SCOPE OF APPLICATION

Replacement of cable-quality PUR (ESCHA term: S570) by cable-quality PUR (ESCHA term: S571)

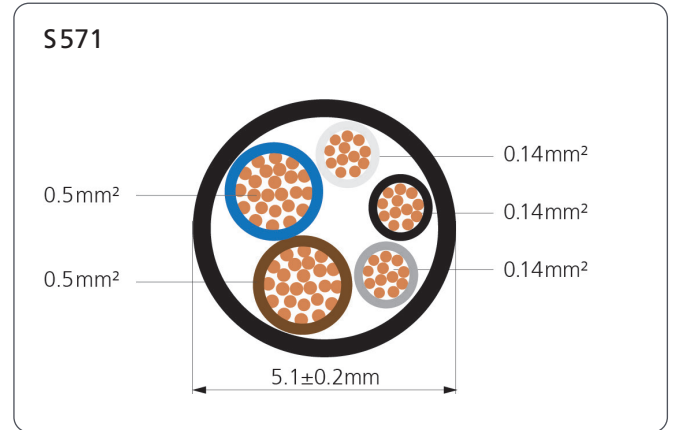
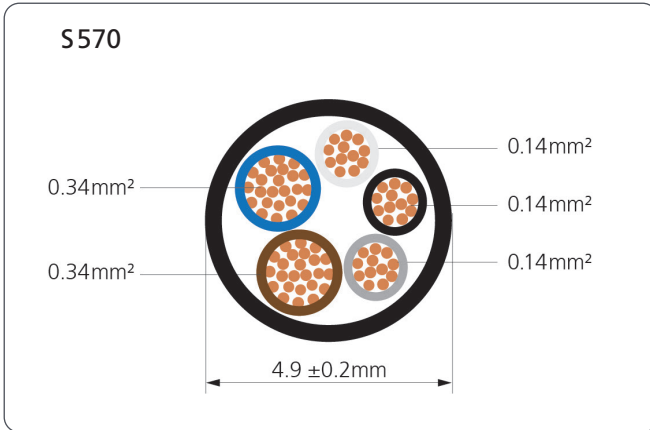
Due to reduce the number of cable-qualities and to consolidate the product-portfolio, we replace the current PUR cable-quality (S570) by the PUR cable-quality (S571).

Cable-quality	Wire cross-section	Jacket diameter
S570	3x0.14mm ² + 2x0.34mm ²	4.9±0.2 mm
S571	3x0.14mm ² + 2x0.5mm ²	5.1±0.2 mm
